ADA Curb Ramp New Construction Inspection Form (Perpendicular)

24952.54

Turel

PERPENDICULAR RAMP (PR)

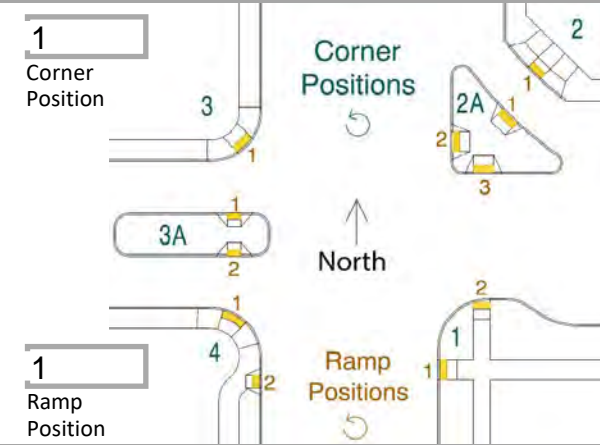
Counter Slope (+/-) *2

5.7

> |5.0%|

☒
